Stage 03: Report to the Authority

National Electricity Transmission System Security and Quality of Supply Standards (NETS SQSS)

GSR025: Updating the SQSS to reflect the recent modification to Engineering Recommendation P28

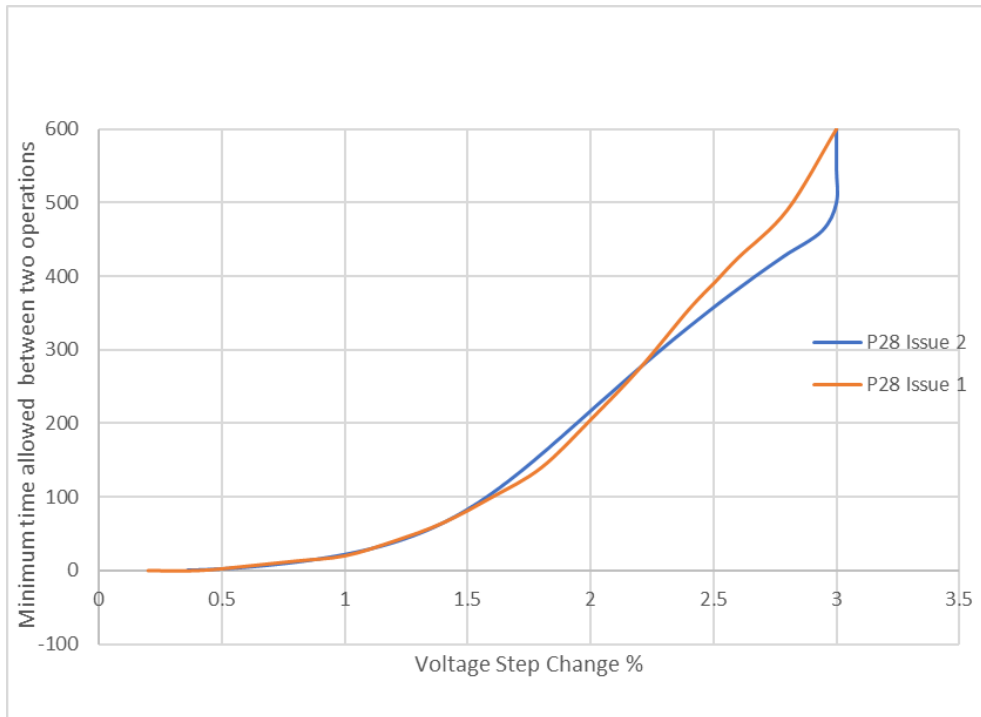
3.1 The minimum time required between two consecutive operations causing a Voltage Step Change of a specific level are shown in Figure 1 below for both P28 Issue 1 and Issue 2.

Figure 6.1 Maximum Voltage Step Changes Permitted for *Operational Switching* derived from ER P28 B.1.2

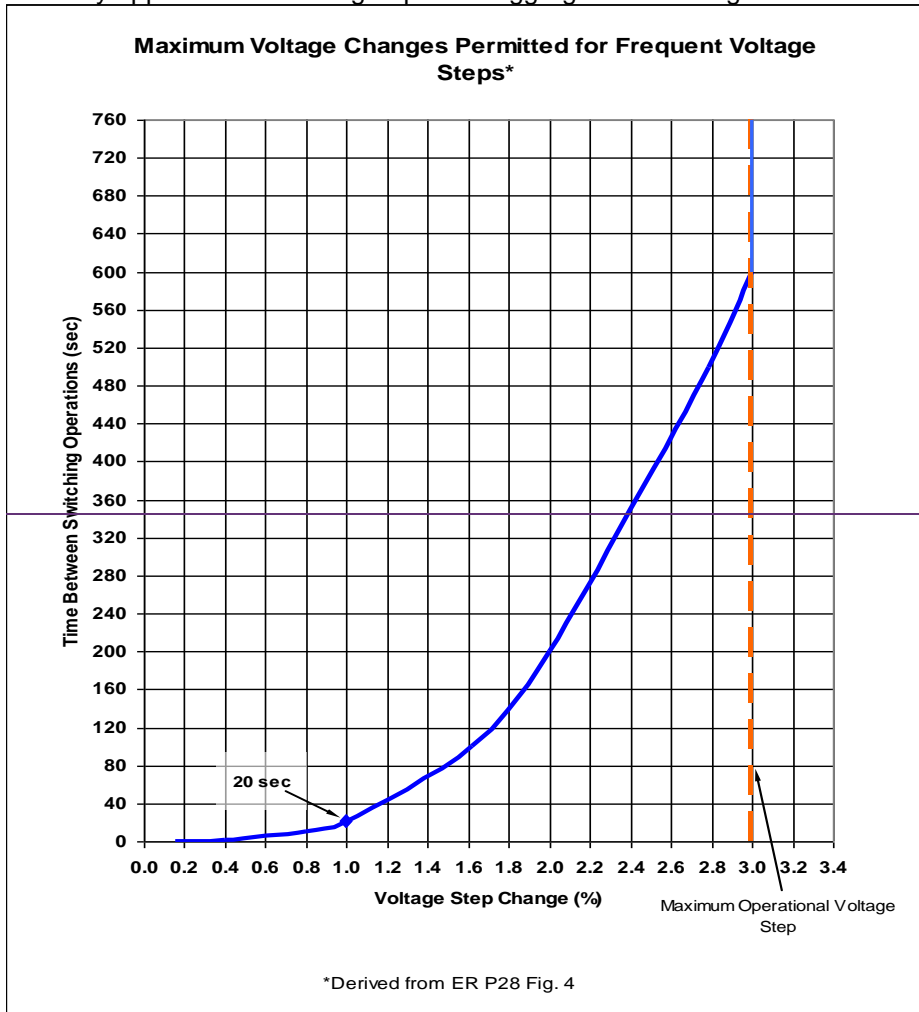
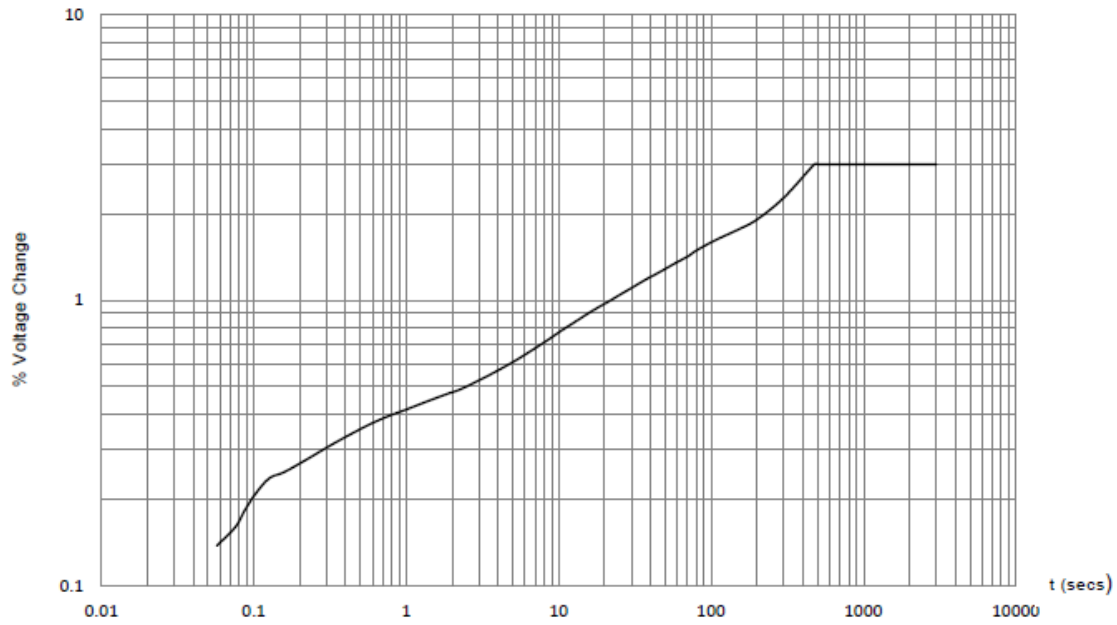
to change Figure 6. which has been updated in Issue 2 of P28. It is proposed that the minor changes are made to Table 6.5 and a new diagram should replace Figure 6.1.

Replace Figure 6.1 of the NETS SQSS by a new Figure 6.1 which is based on Figure B1.2 of the new EREC P28 Issue 2.
